# Groundwater Application Review Summary Form

Application # G- 18516

GW Reviewer Jen Woody Date Review Completed: 7-28-2017

**A. GENERAL INFORMATION:** Applicant's Name: Durant Vineyard County: Yamhill

Figure 2. Well Location Map

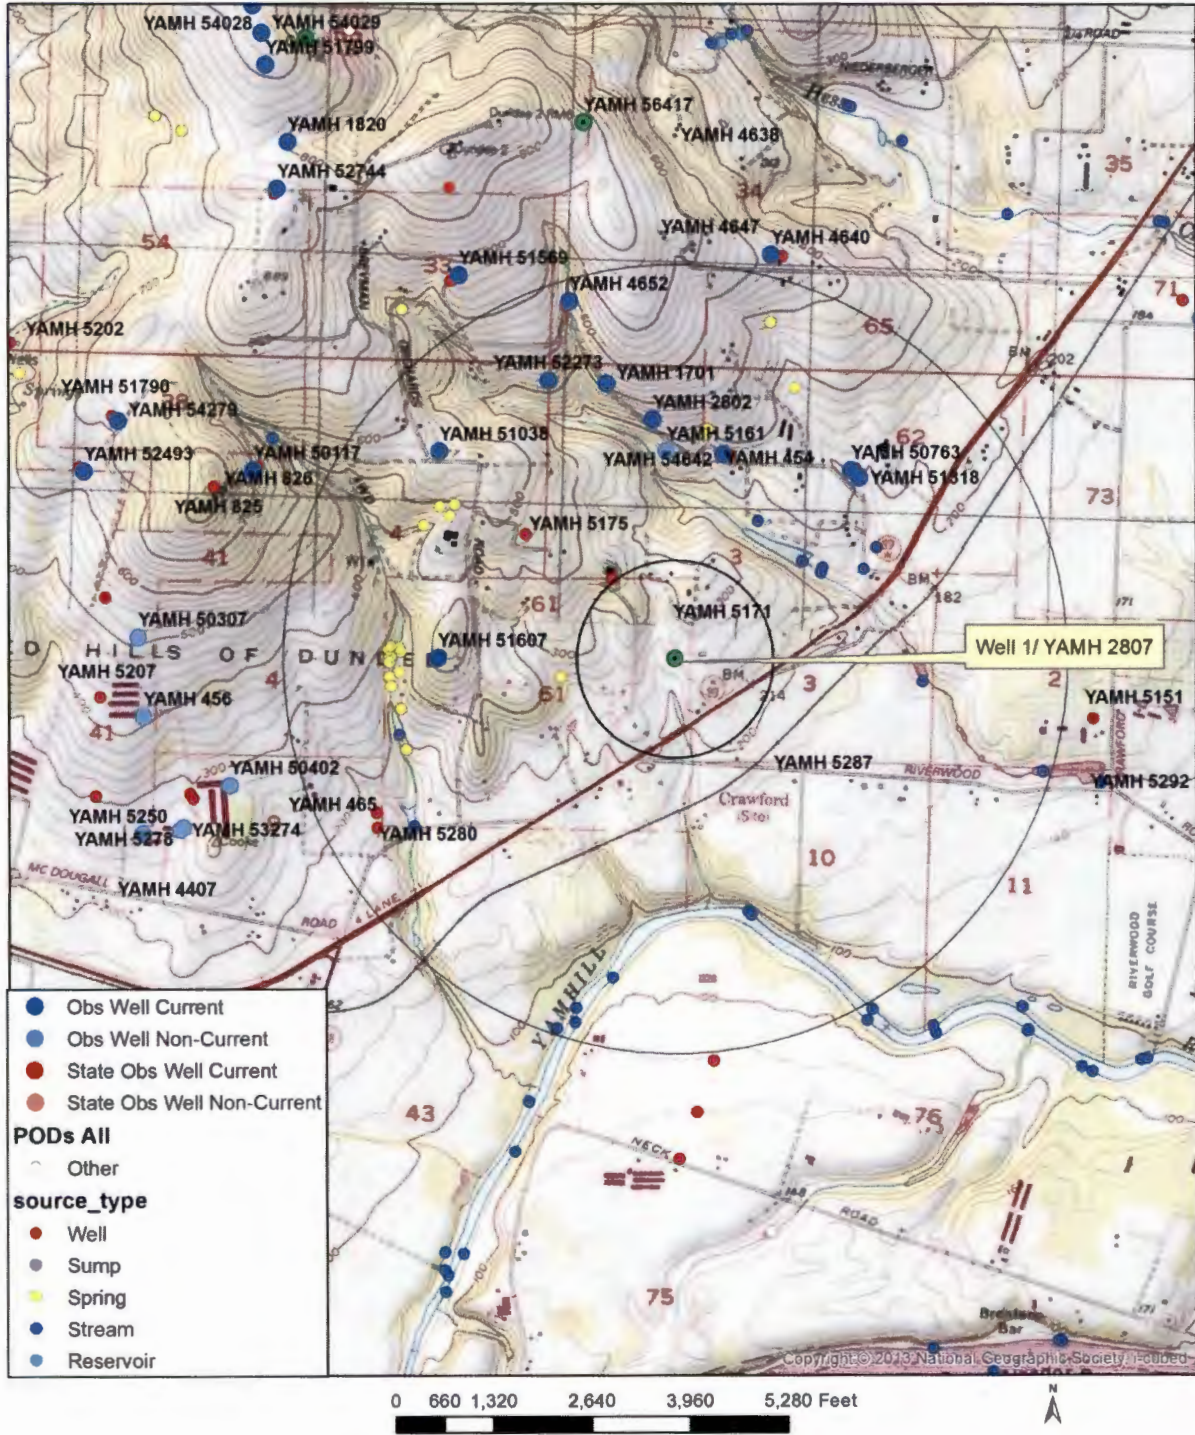
G 18516 Durant  
T4S/R3W- Section 3
